**NEW ANIMAL SHELTER
225 MAPLE AVENUE
MONTVILLE, CT 06353**

S/P+A PROJECT #22.130

DATE: November 27, 2023

The following changes to the Drawings and Project Specifications shall become a part of the Drawings and Project Specifications; superseding previously issued Drawings and Project Specifications to the extent modified by Addendum #1.

Job No. 22-24
 Scale: 1"=30'
 Date: 10/2/23
 Designed: D.W.S.
 Drawn: K.D.K.
 Sheet: C100

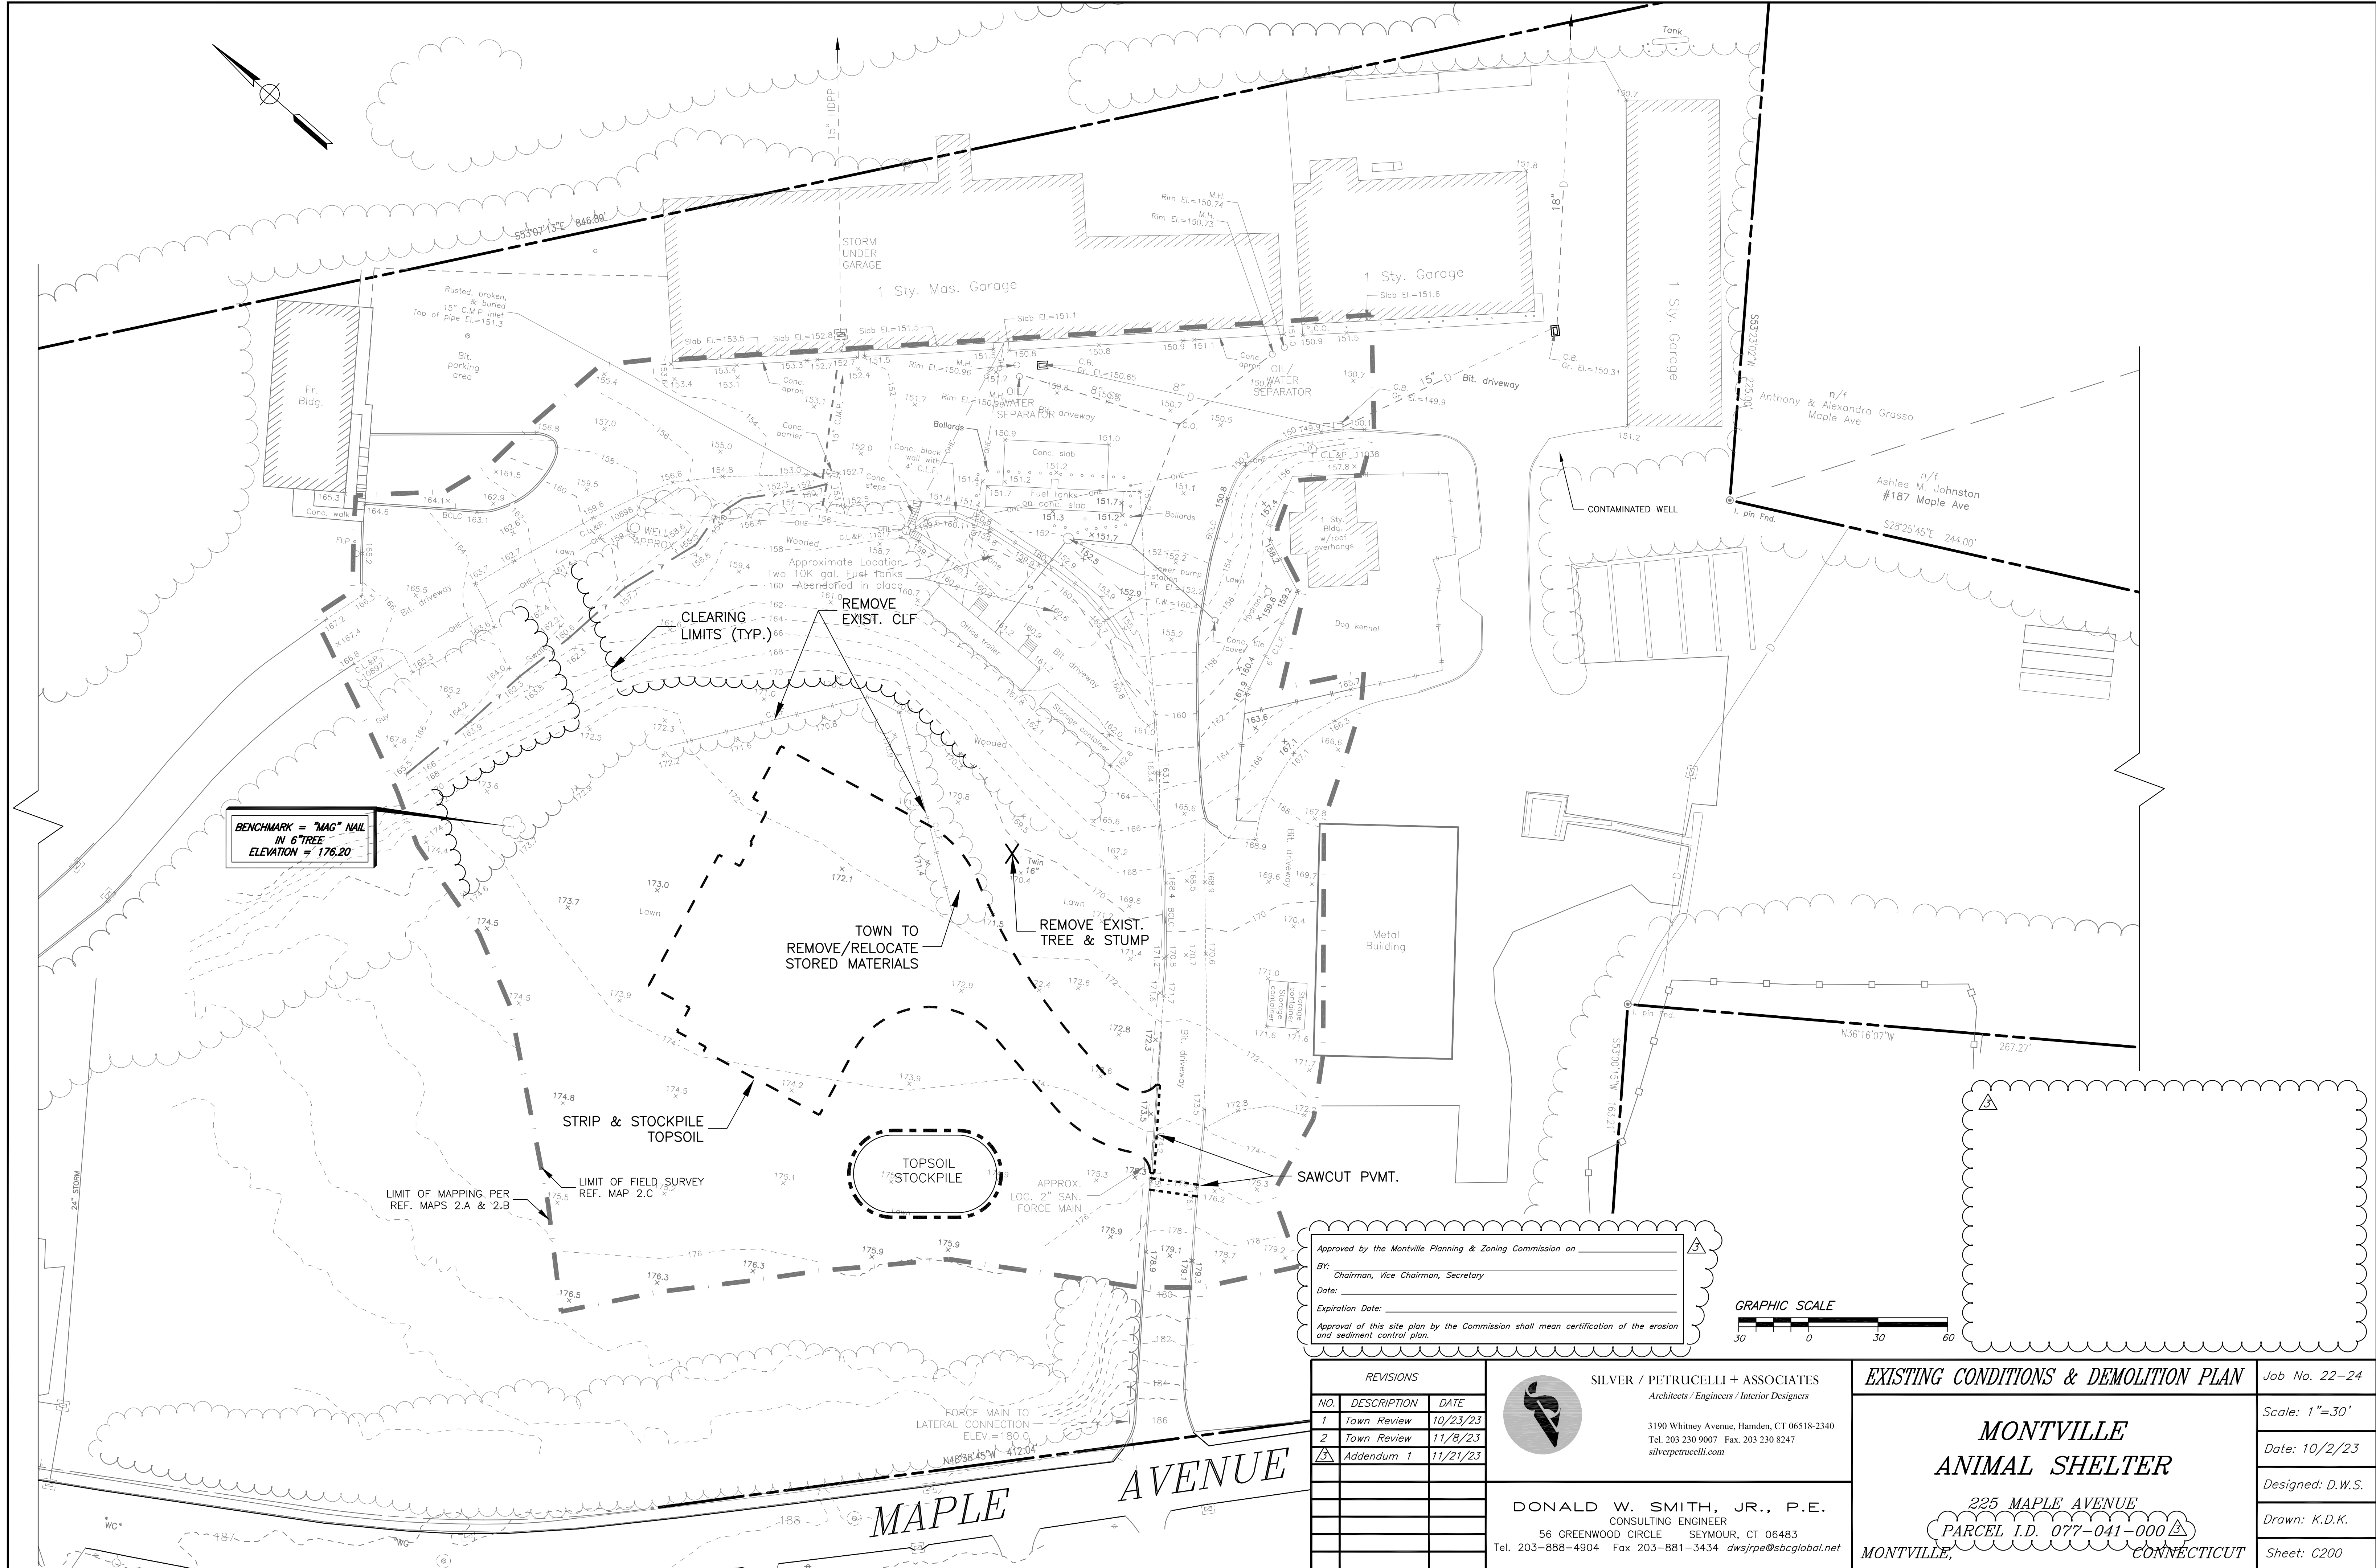
| RFI # | QUESTION | DATE RECEIVED | RESPONSE | ADDENDUM # ISSUED |
|-------|--|---------------|---|-------------------|
| 014 | Please provide specifications and details for 24 LF of timber guardrail shown on drawing C100. | 11/21/23 | Refer to Addendum #1 for revised drawings. | 1 |

Drawing Number:
A600

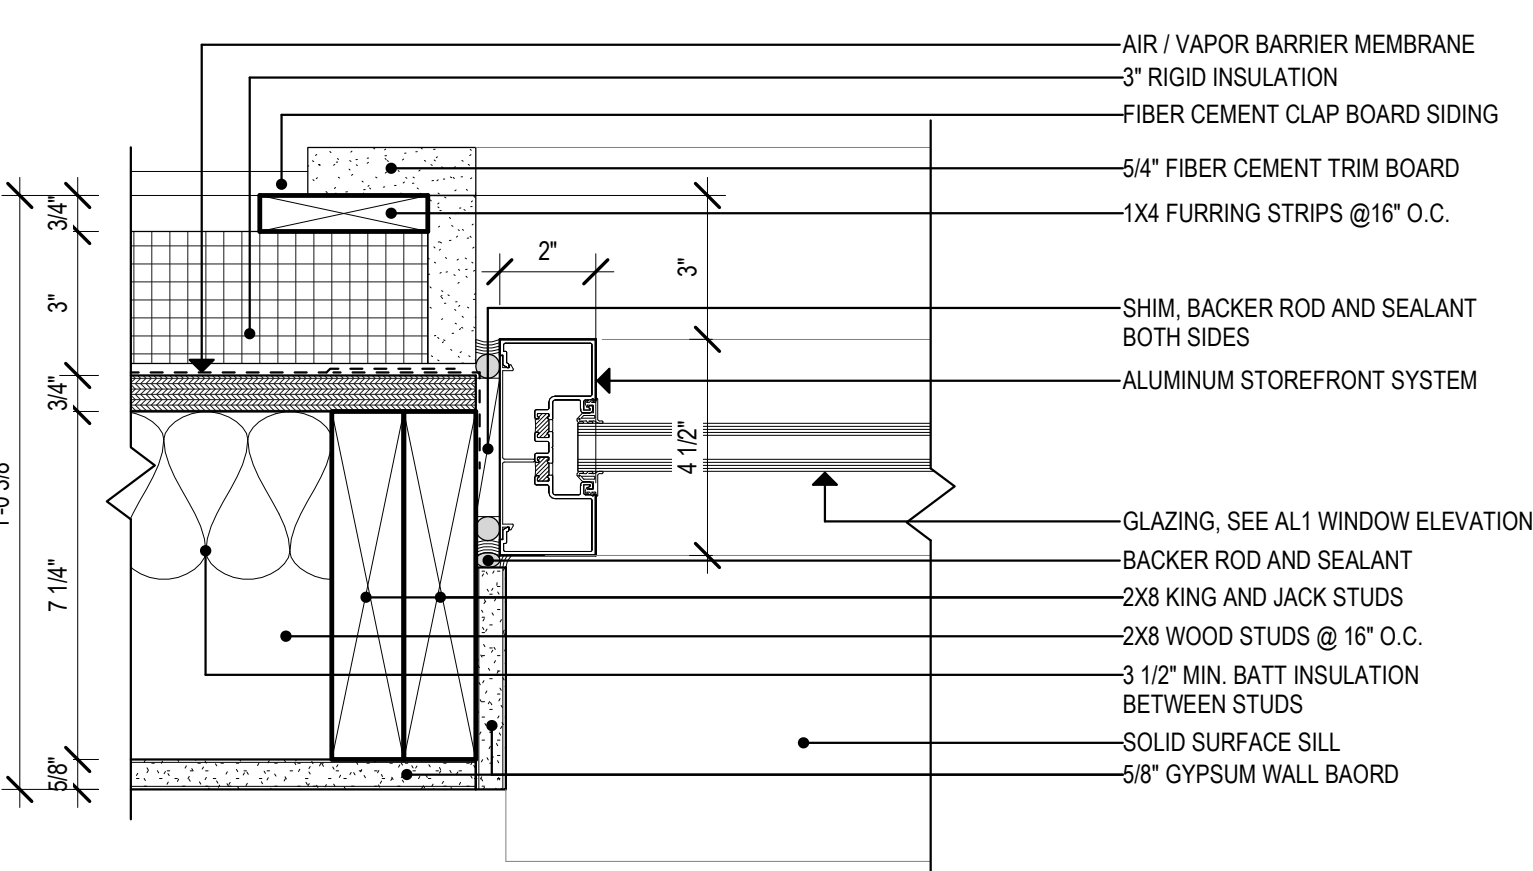
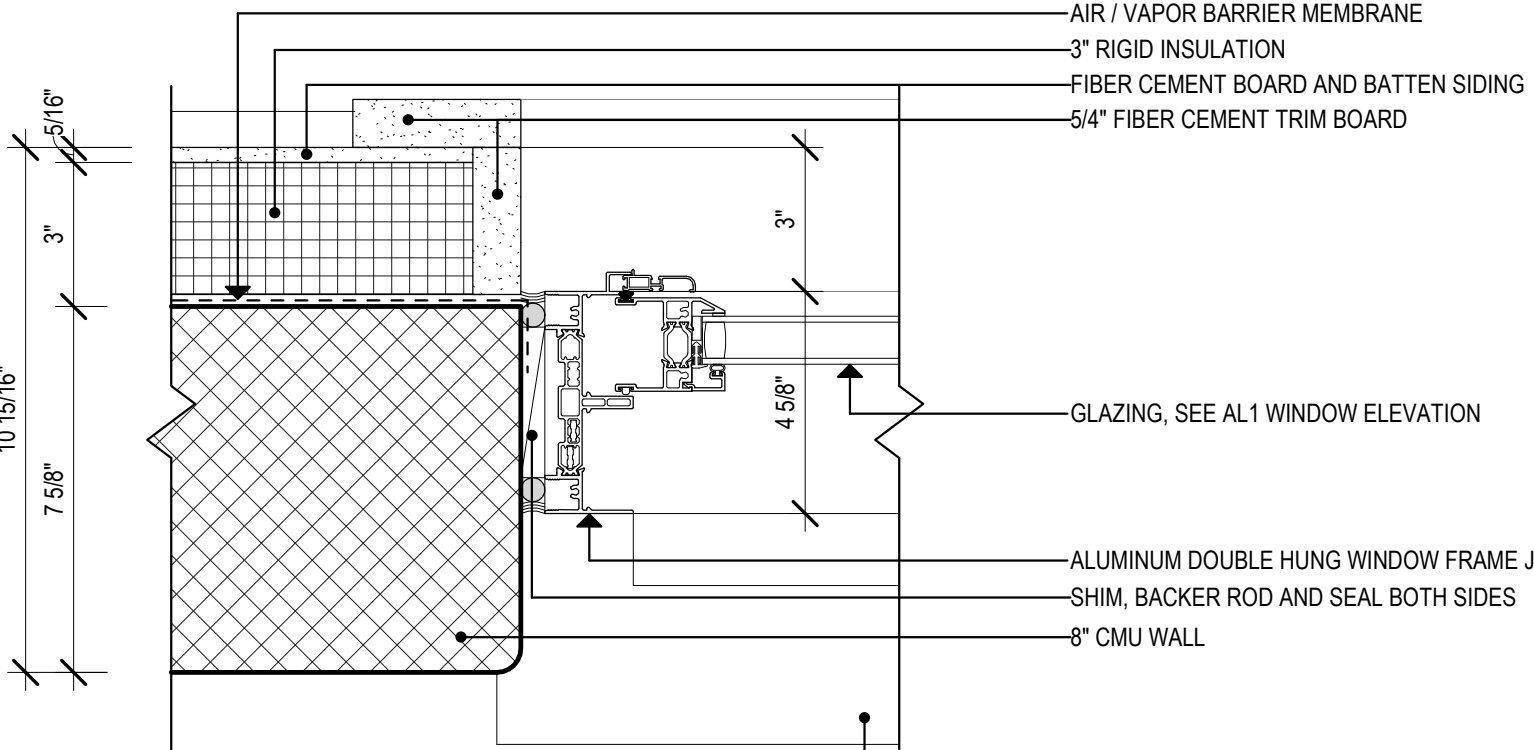
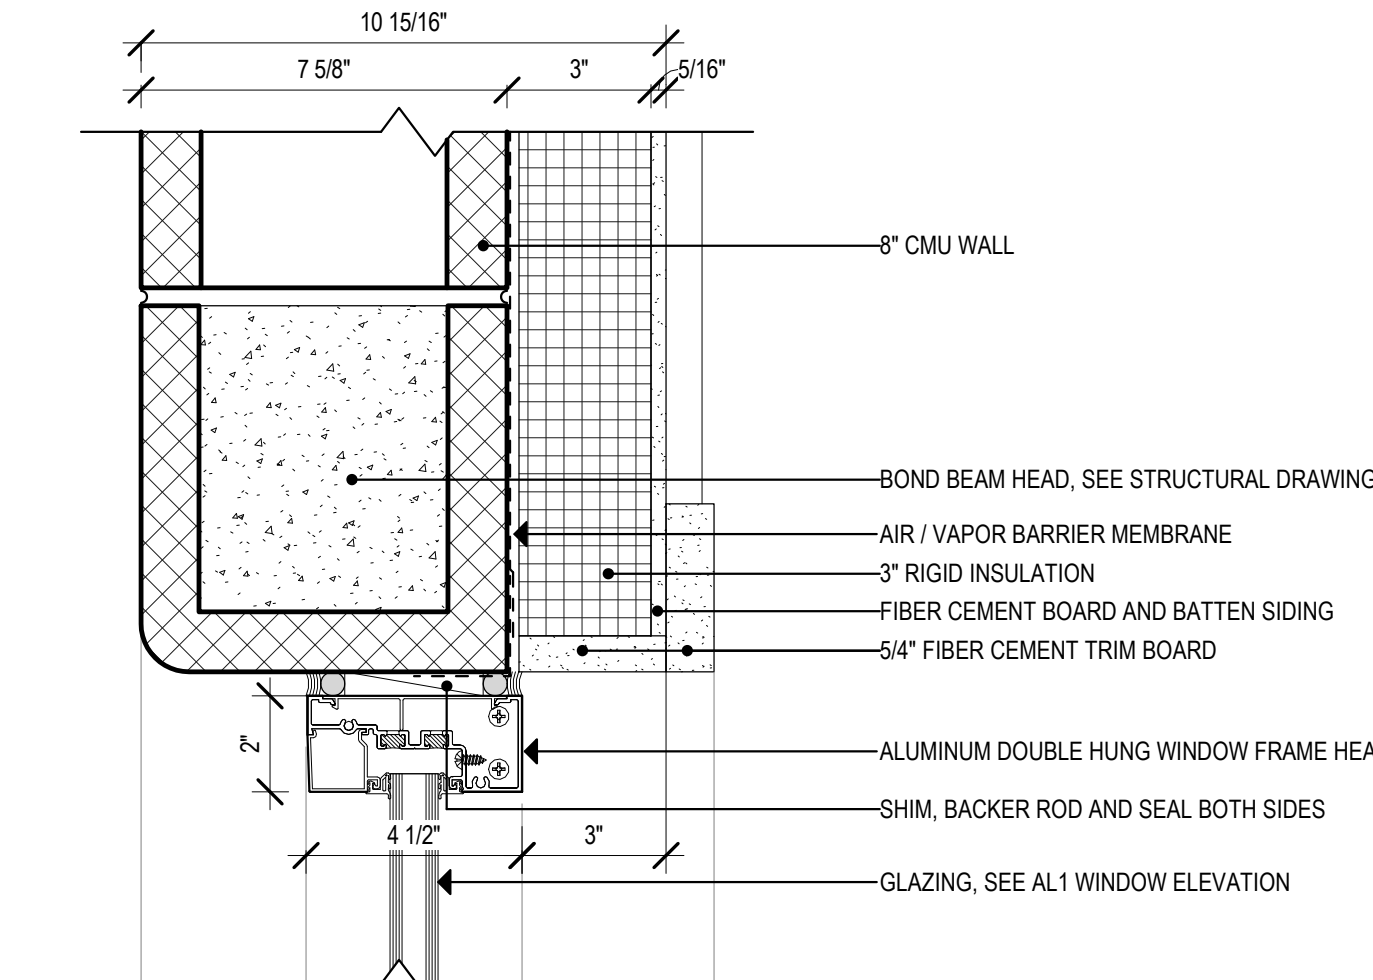
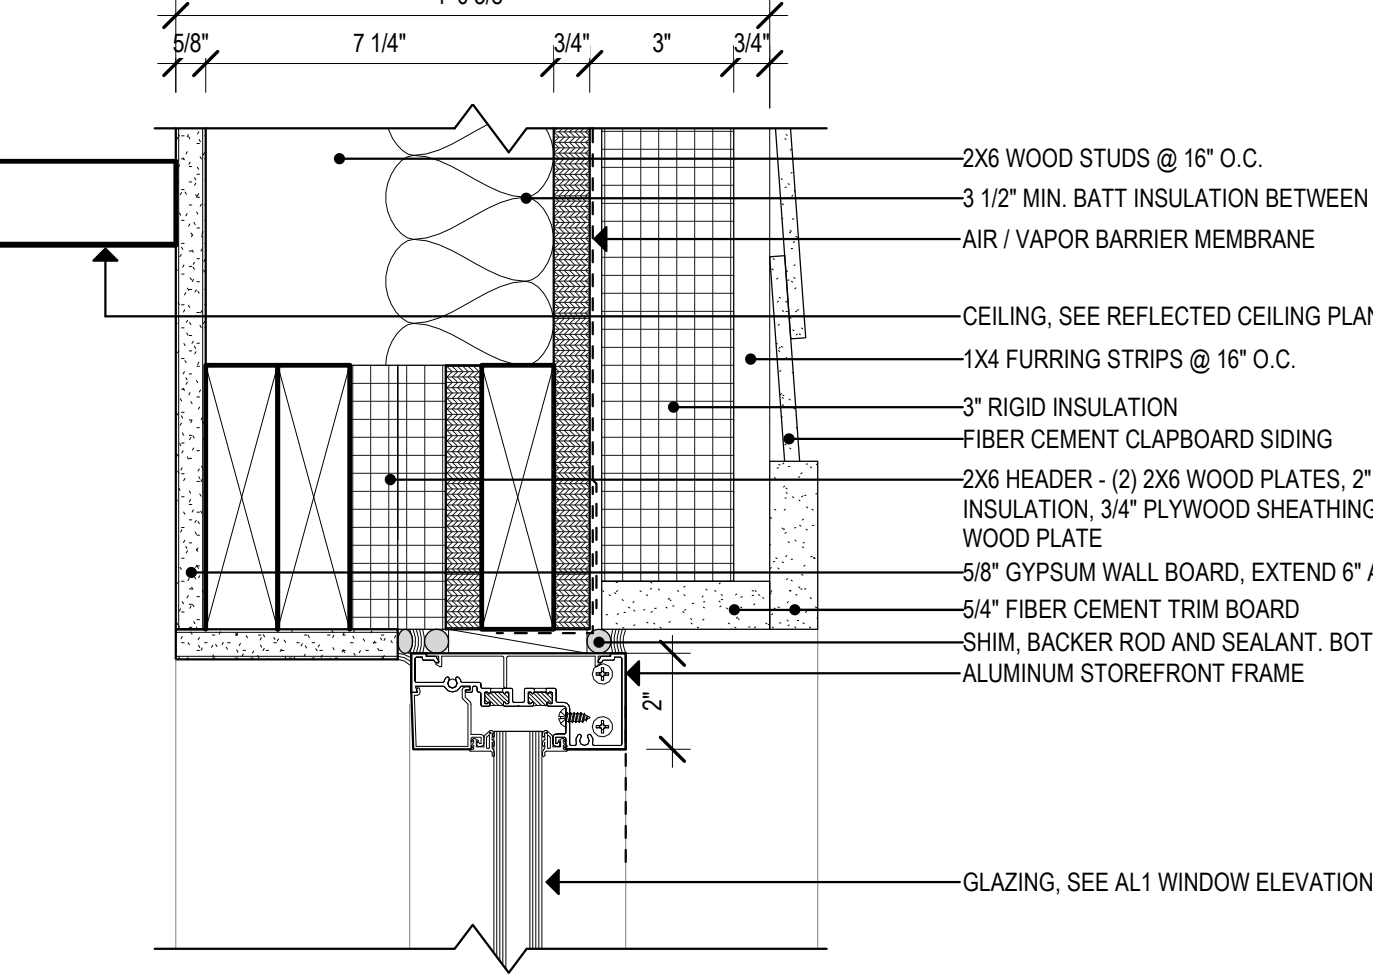
| RFI # | QUESTION | DATE RECEIVED | RESPONSE | ADDENDUM # ISSUED |
|-------|--|---------------|---|-------------------|
| 016 | Specification section 084113-2.3-A-3 calls for the glazing plane to be front, while drawings A600 depicts center plane. Which is correct? | 11/21/23 | Center plane is correct. | 1 |
